1657 CARLING AVENUE

DESIGN BRIEF

01 October 2024

ORIGINAL DESIGN SUBMITTED TO UDRP

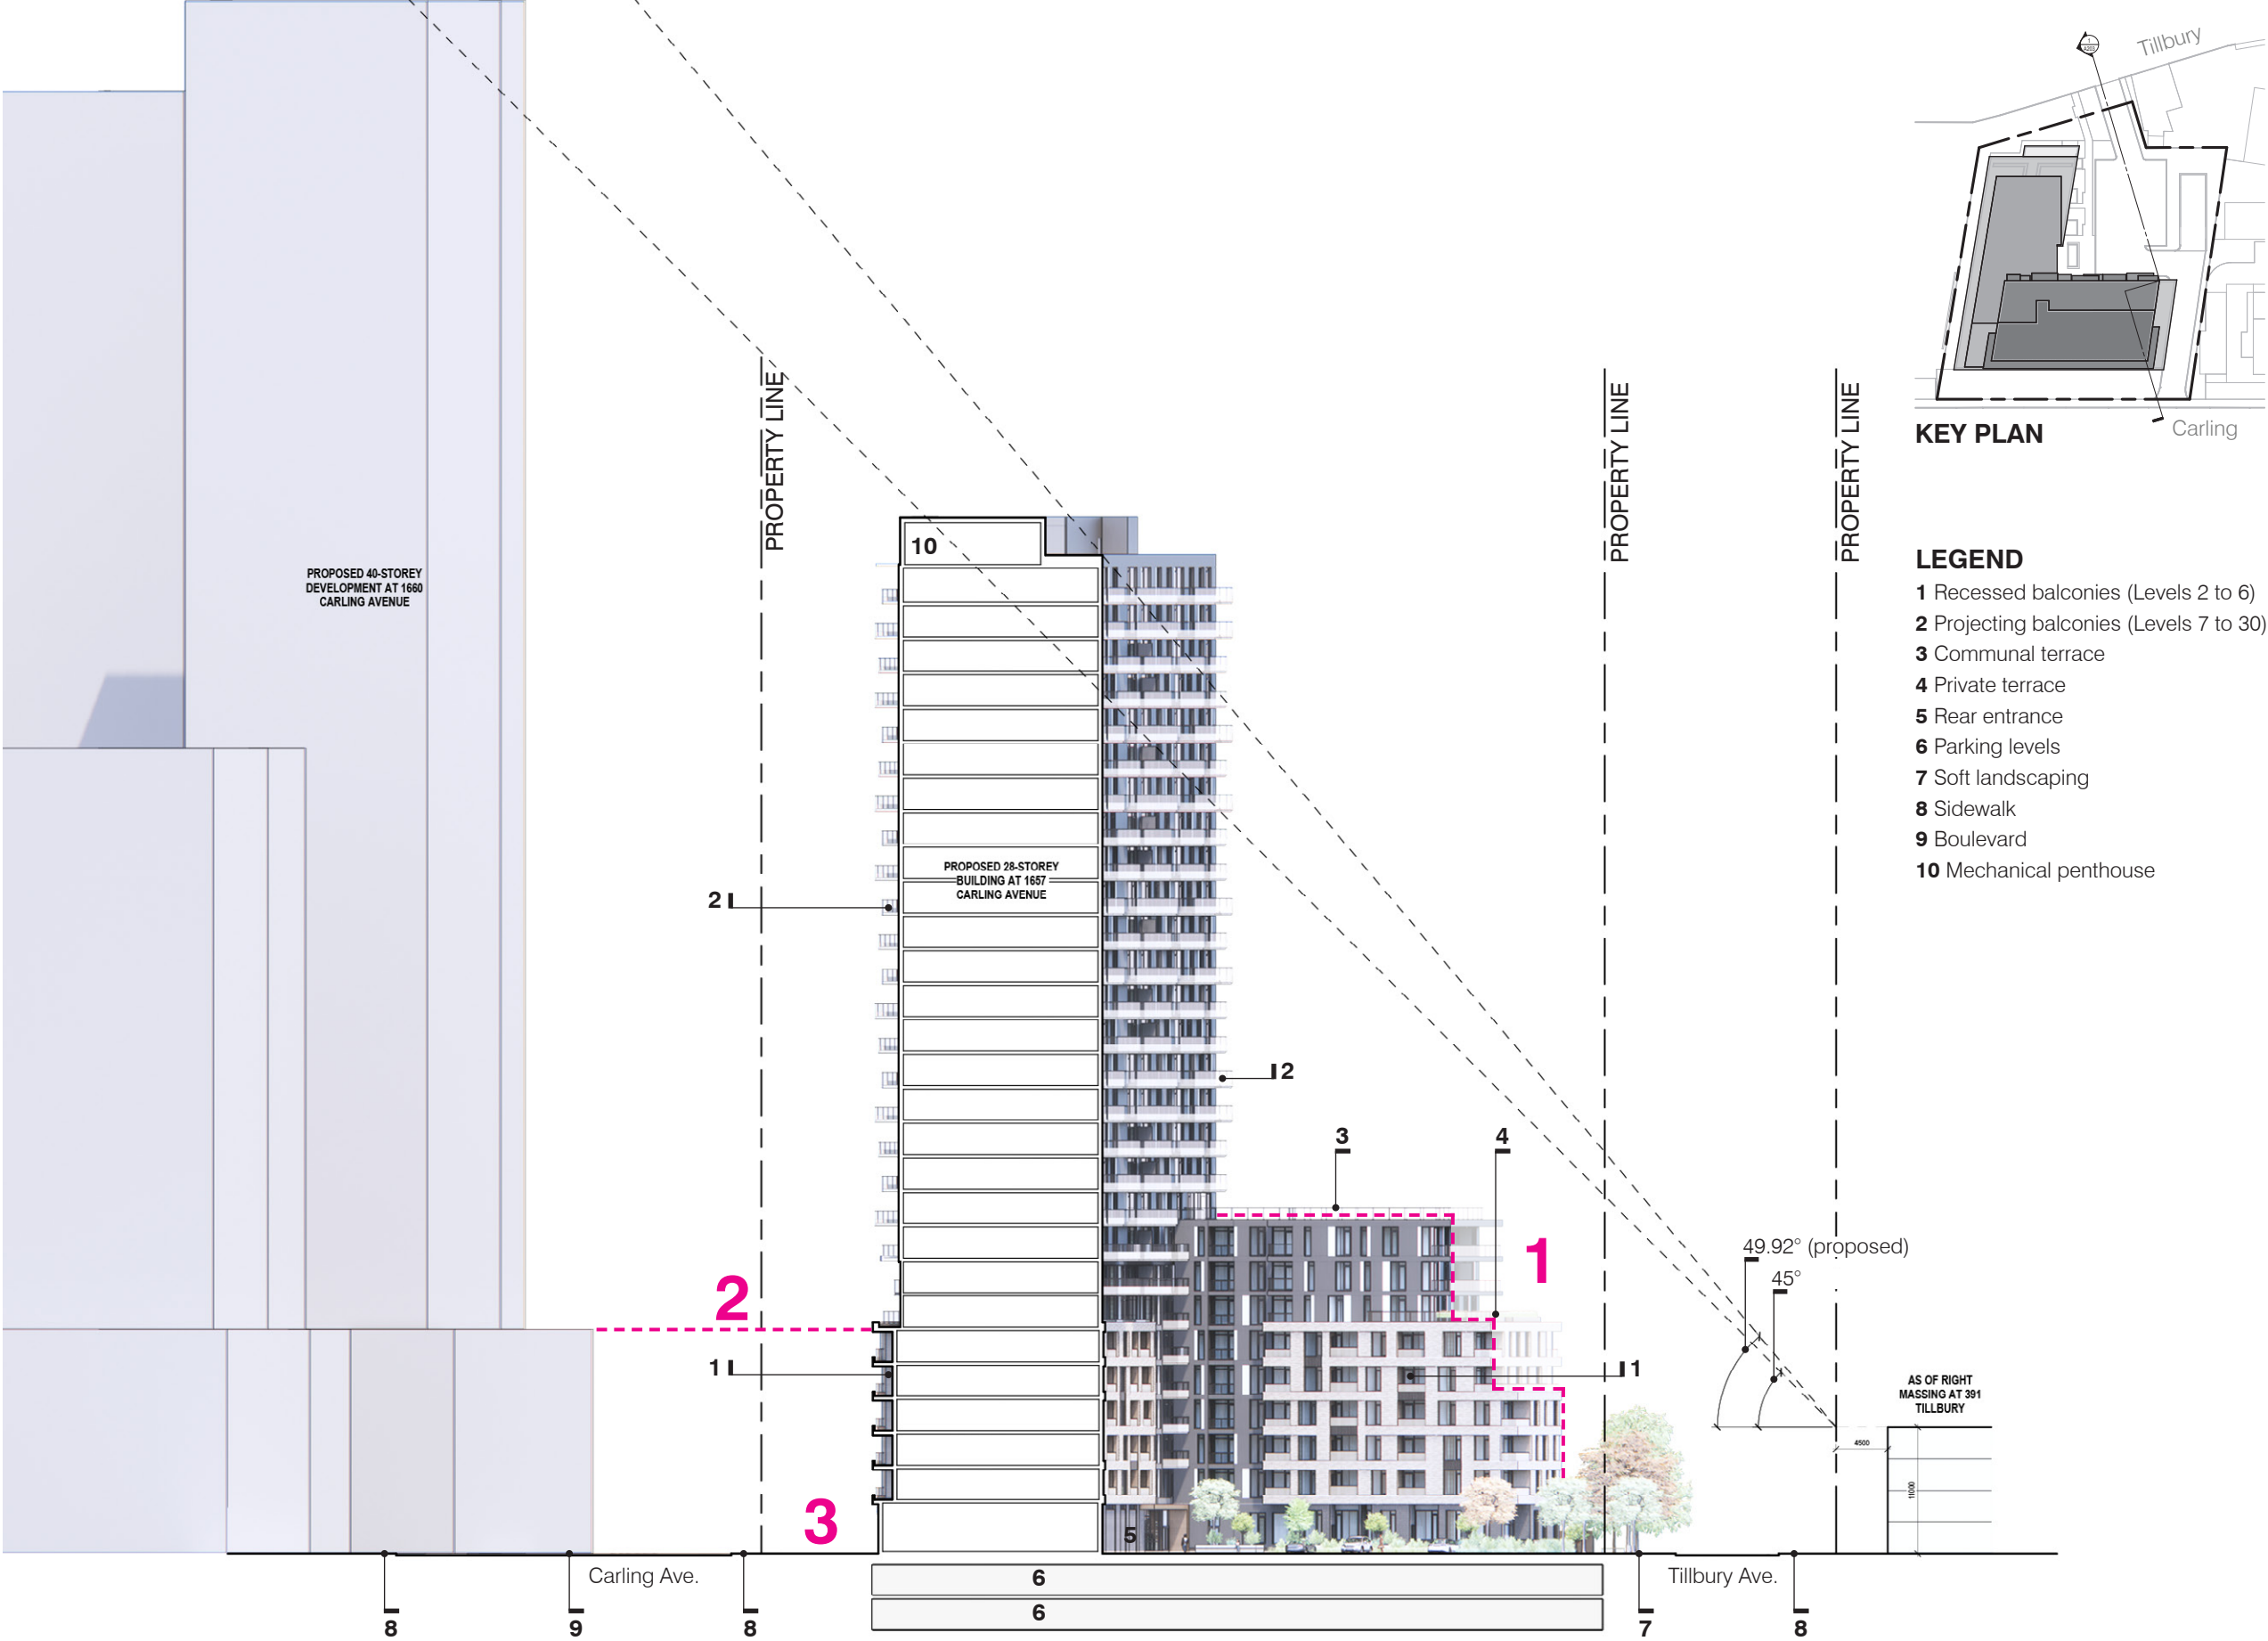
- The Panel has concerns with the 30-storey height proposed for the building and the angular plane from residential on Tillbury Avenue. A much stronger planning argument is needed to allow for this height at this location.
 - Consider the height of the building directly east on the north side of Carling Avenue is 16-storeys. There is not a strong rationale for more height at this location, given what was granted to 1655 Carling Avenue

- The Panel cautions against too much use of starkly dark materials.
 - Consider lightening up the entire tower portion of the building. The play of light and shadow through the variation in balconies would be more pronounced.

- The Panel highly recommends a 6-storey podium, foregoing the 7th-9th storey portions that go beyond the tower floorplate.
 - The Panel suggests it would provide for a cleaner form of architecture if, beyond the 6-storey woven podium, the building immediately transitioned to a tower starting at the 7th floor, thereby removing the current ‘transition’ space that adds superfluous building area and bulk to the building.
While the panel may consider this to be ‘superfluous building area’, eliminating this transition would result in the reduction of building area by approximately 17,000 sqft and the loss of 21 units residential suites. Unless the panel is suggesting that we could recapture this lost area with increased building height, we would like to make clear that this area is critical to the viability of the project as designed.

The initial design proposed a 30-story tower, featuring alternating angled balconies with fritted glass panels at varied elevations, evoking the natural striations of geological formations. The podium is articulated in medium grey brick, providing a strong visual base, while the tower above is clad in black with blue accent panels to enhance the structure's sleek profile. On the west elevation, levels 7 to 9 are recessed by 3 meters, aligning with the setbacks of the lower levels, and are complemented by a fritted glass canopy at level 8. The podium's design, coupled with the slightly recessed ground floor, creates a visually striking effect of a floating structure, elevating the building to enhance pedestrian engagement and maximize the use of public space at street level.

The current design responds to concerns raised in the UDRP comments by incorporating the following changes:

- The tower height has been reduced from 30 to 28 stories.
- Levels 7-9 have been set back an additional 2.5 meters on the west façade to create a more seamless transition to ground.

- The south podium façade and tower have been shifted 3.3 meters back from Carling Avenue, in compliance with ROW requirements.
- The canopy above level 8 has been updated to a black finish, enhancing the contrast with the tower's balconies.

- The blue accent panels have been refined to a more subdued silver tone.
- The design of the tower balconies has been revised for greater cohesion with the podium expression, while continuing to evoke the layered effect of geological striations.

- The podium's brick tone has been lightened, and the ground floor footprint has been reconfigured to incorporate protruding columns in the same tone, extending the brick material to further anchor the podium and provide a stronger connection to the ground level.

1657 CARLING AVENUE FLOOR PLAN - GROUND FLOOR / CONCEPTUAL LANDSCAPE PLAN

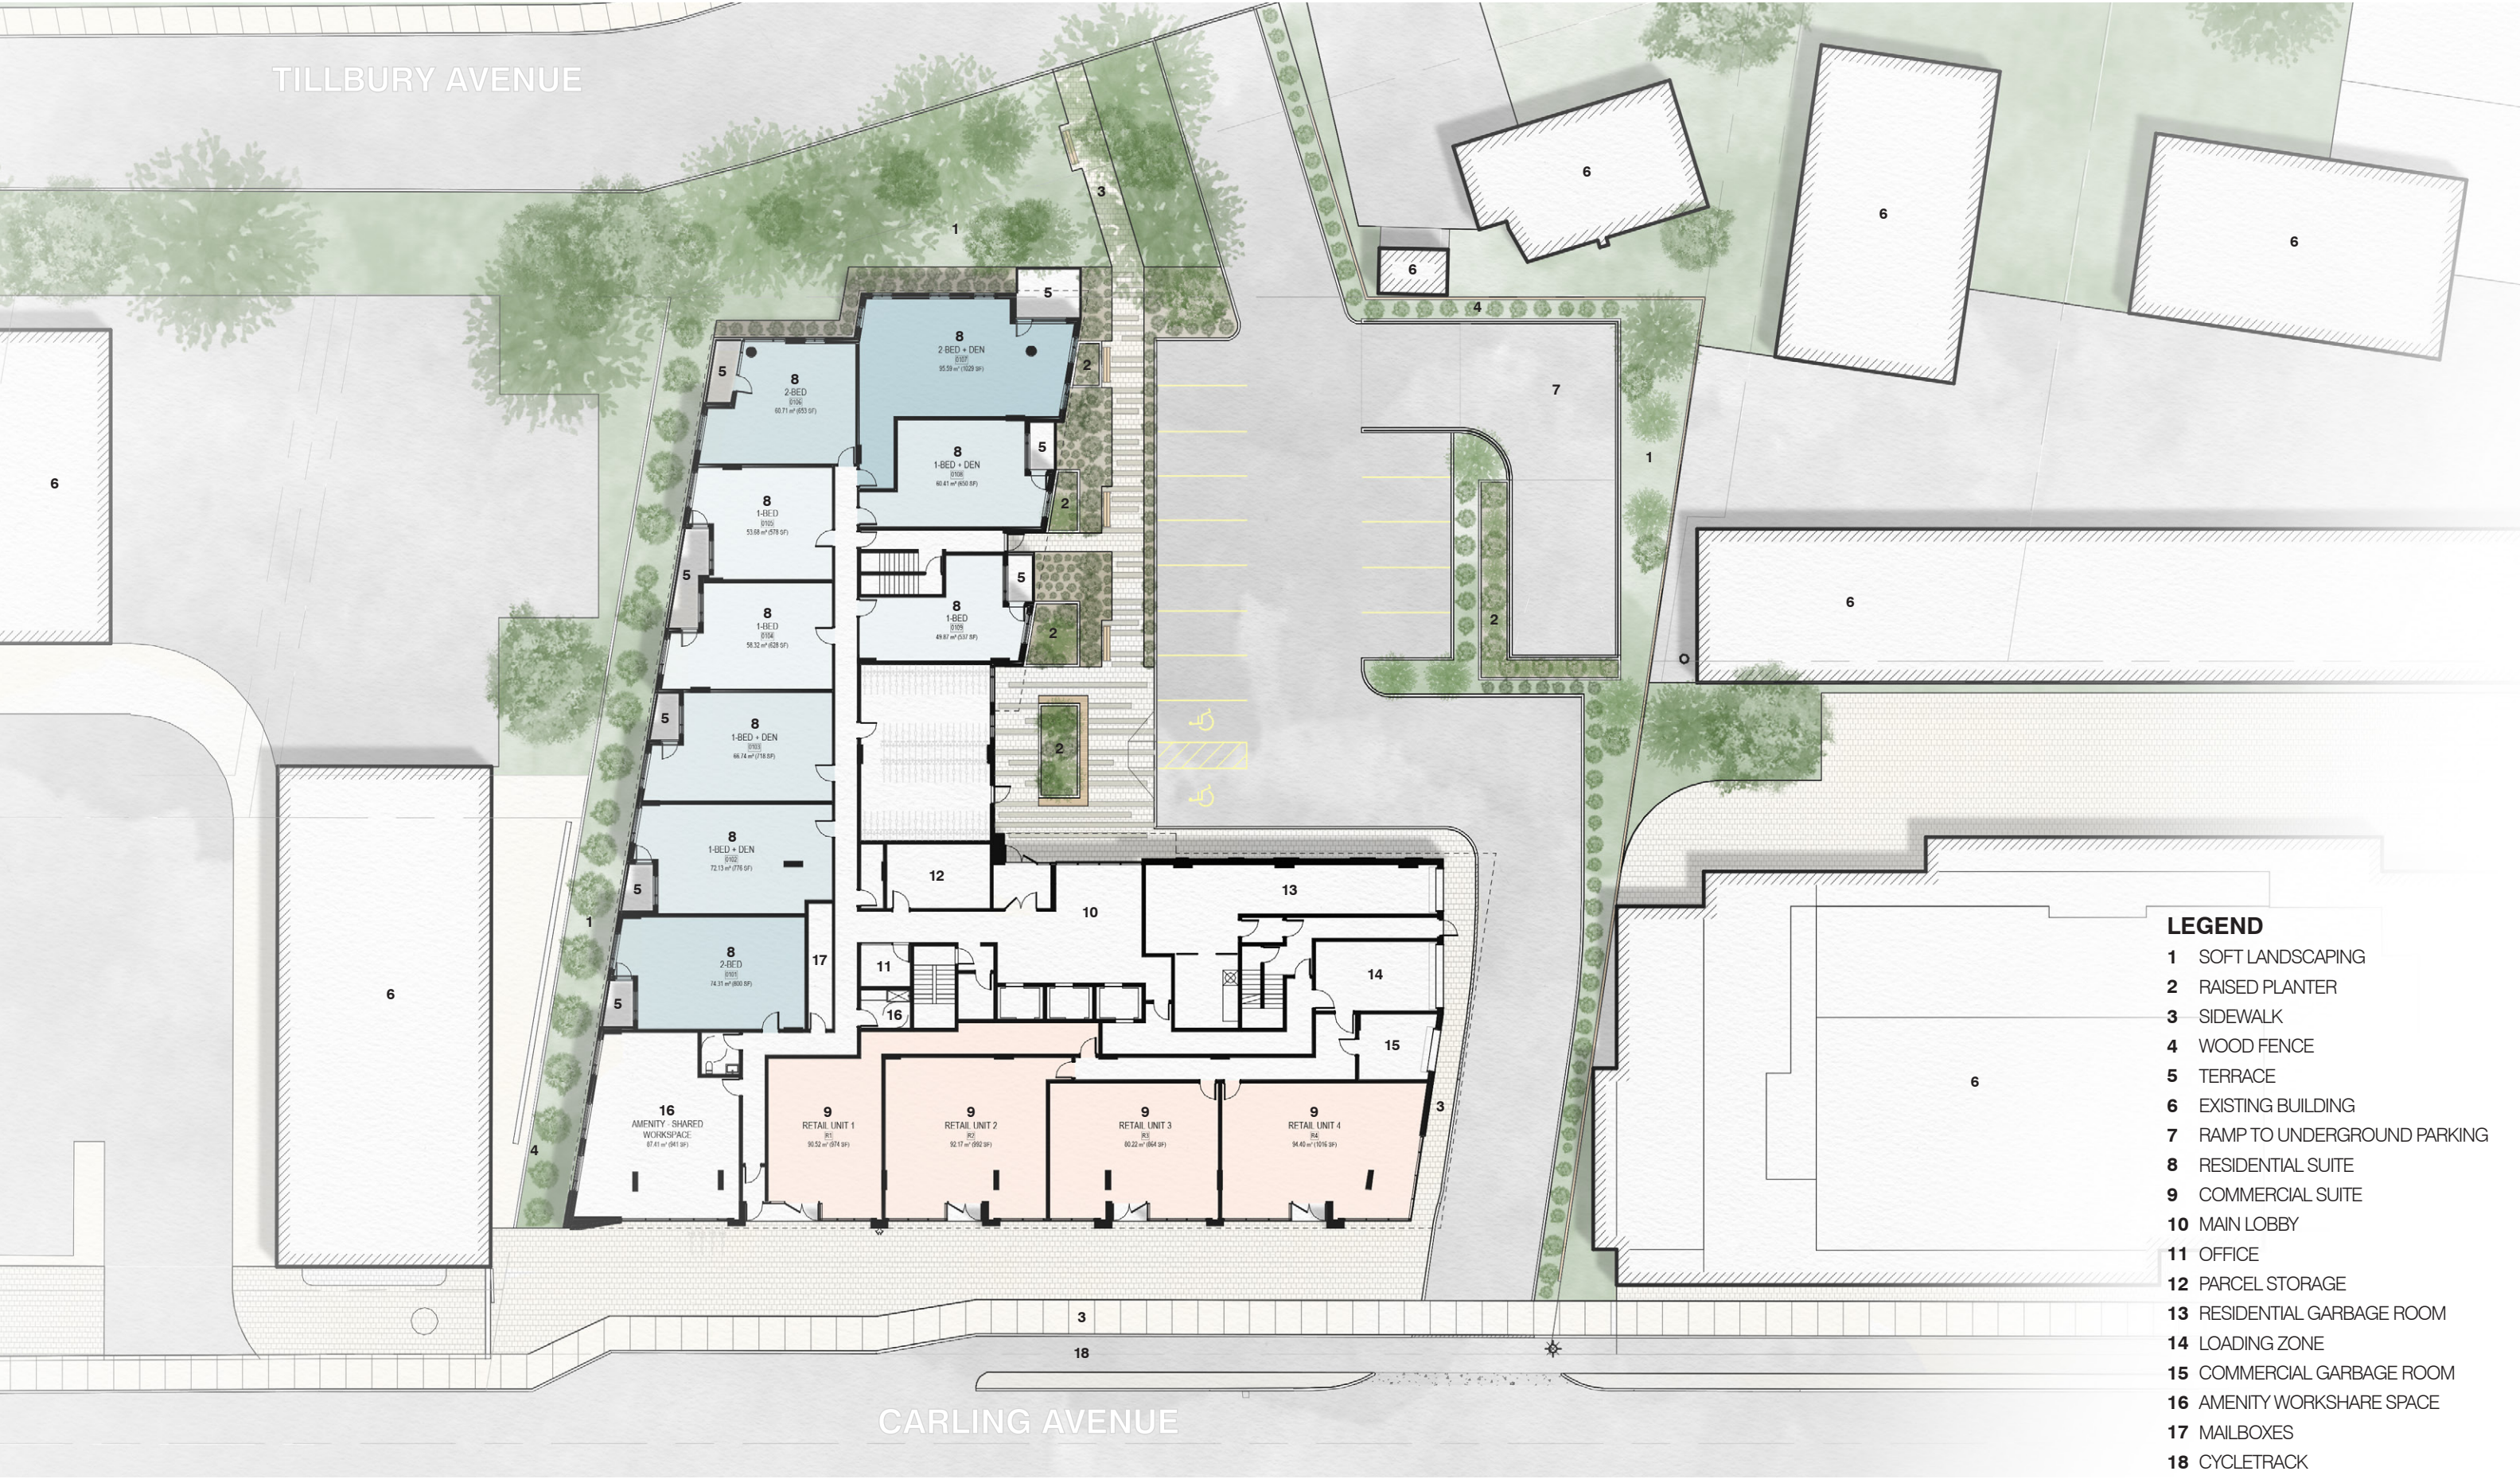
- The Panel has concerns with the 3m side-yard setback being proposed along the western property line. The 3m interior side yard setback is along the face of the building in areas intended for bedrooms. Living spaces will be adjacent the recessed patios and balconies which offer an additional 1.5m setback. A 4.5m setback is a very liveable and will offer no ill effects on the few units that have this exposure. Keep in mind as well that the development on the neighboring property to the east has much tighter interior side yard setbacks that go down to zero in some locations.

- The Panel appreciates the description in the presentation of this parking area as a courtyard space, however what is currently proposed reads as a parking lot.
 - Consider adding more landscaping in order to create a courtyard space. A lush courtyard space will also create a buffer from Tillbury Avenue. The courtyard design should be explored further in order to fulfill the description and intended vision for that space.

- The Panel recommends implementing a surface treatment in the ‘courtyard’ space that is more consistent with a pedestrian-first space.
 - Consider blurring the lines between the pedestrian landscaped portion and the vehicular space by using paver treatments and landscaping as a means of creating a more pedestrian-first environment overall.
 - The specifics of the hard landscaping will be further developed during the site plan control submission, however there are concerns over cost and long-term wear related to using paving stones.
 - Consider designing the forecourt area as a woonerf style courtyard.
 - This can be considered as we develop the landscape design further.
 - Consider reducing the number of surface parking spaces proposed.

- The Panel recommends removing the amenity space on the ground floor or merging it with a through-lobby entrance at the corner of the building.
 - Consider moving the bike storage space to the west side of the building, closer to Carling Avenue and creating a through-lobby area.
Noted.

- Consider placing any ground floor amenity space on the courtyard/forecourt, potentially swapping with the bike storage area.

We are confused by this comment as we described in detail the landscaping shown in the design package. The building has a very generous setback from Tillbury in order to create a park space and this park is then carried into the courtyard of the building. This includes features such as raised planters, benches and other elements of outdoor furniture. Separating the parking from the ramp is another area of planting which is meant to obstruct the view of the ramp and will include small trees and taller shrubs.

While we have yet to complete a landscape plan, this will be done for the site plan control submission, where we will also provide more specifics of the specific planting being proposed to ensure that this space feels like a courtyard and not simply like a parking lot.

We foresee a practical need for these surface parking spaces to properly serve the building. That said, we will look to see if we can remove one or two parking spaces in the future.

We strongly disagree with the suggestion to position a bicycle storage room along the street frontage instead of an amenity space that is designed to promote interaction with the street. Note that the primary outdoor amenity space for the building will be the terrace on the 10th floor facing north, which also features an indoor amenity room. The courtyard space at the entrance to the building is meant more to create a sense of arrival and to facilitate departure.
